U.S. Army Corps of Engineers Information Needs – June 2009

Preparation for Bellefonte Units 3 and 4 Corps of Engineers Site Visit, July 8-10, 2009

COE INFORMATION NEED: COE-1

FIGURE 8.4-4
Need for Baseload Capacity

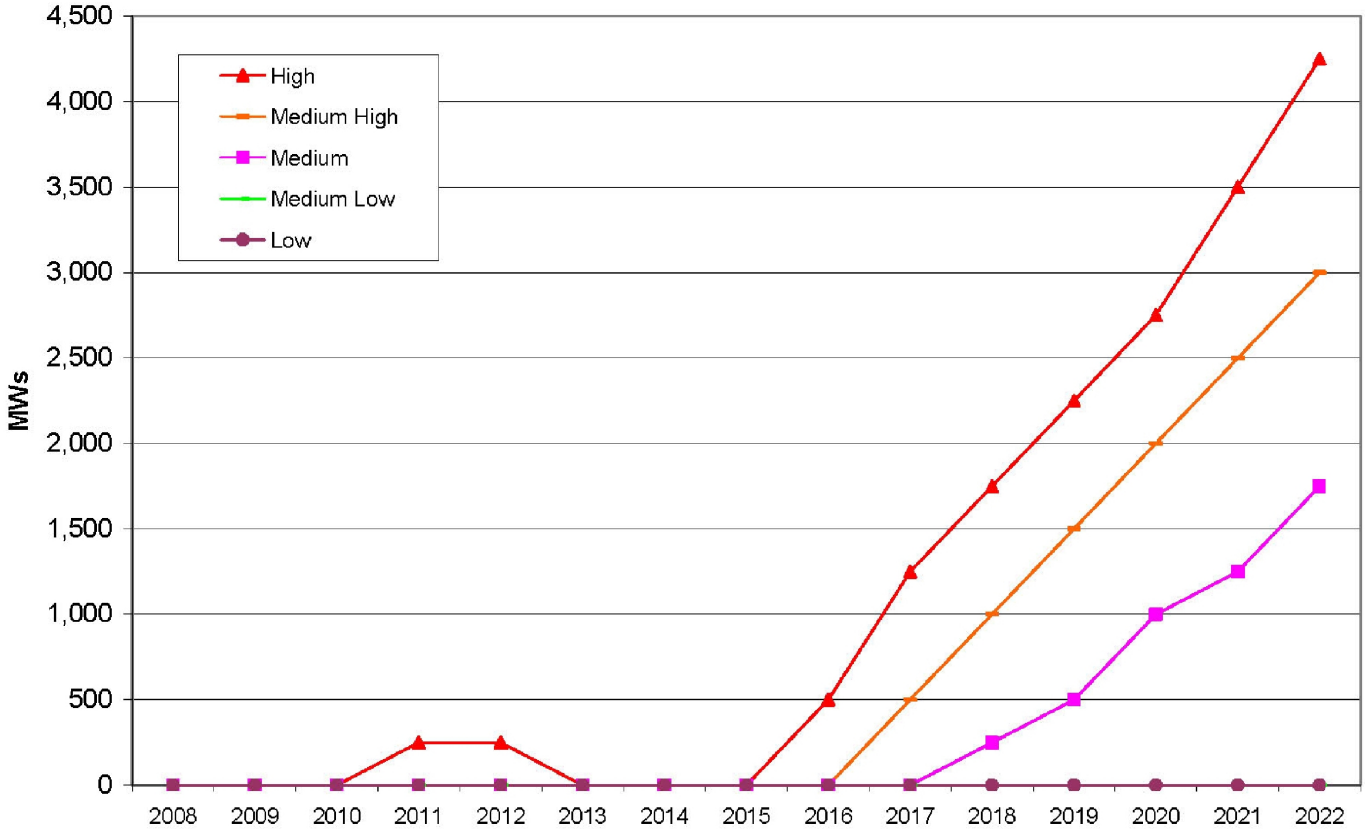
Provide an SME that can discuss the purpose and need for the BLN 3 and 4 project. The discussion should include a definition of the regional area where additional base-load electrical generation capacity is needed and identify the amount (megawatts) of baseload power needed.

"TVA determined how much of the total capacity need in Figure 8.4-3 should be baseload generation based on an assessment of energy needs. The total expected generation of existing and planned capacity resources, Table 8.3-1, is compared to the forecast net system requirements, Figure 8.2-5, to forecast the amount of energy surplus or deficit for each year of the planning period. If there is an energy deficit, then some of the additional capacity needs should be met with baseload resources. The amount of baseload capacity needed is determined by comparing the existing and planned resources (Table 8.3-1) to the average load. Figure 8.4-4 illustrates the deficit in baseload capacity by load forecast by year. In those

years with a balanced energy supply or an energy surplus, the deficit is shown as zero. Figure 8.4-4 shows that baseload need under the medium load forecast begins in 2018 and grows to 1750 MWs by 2022. Except for a short term need in 2011 – 2012 under the high load forecast, baseload need begins in 2016 under the high forecast and 2017 under the medium high forecast, and is greater than 2,000 MWs by 2019 and 2020 respectively. Information in Tables 8.4-3, 8.4-4 and 8.4-5 provides data prescribed in NUREG-1555, Tables 8.4-1 and 8.4-2."
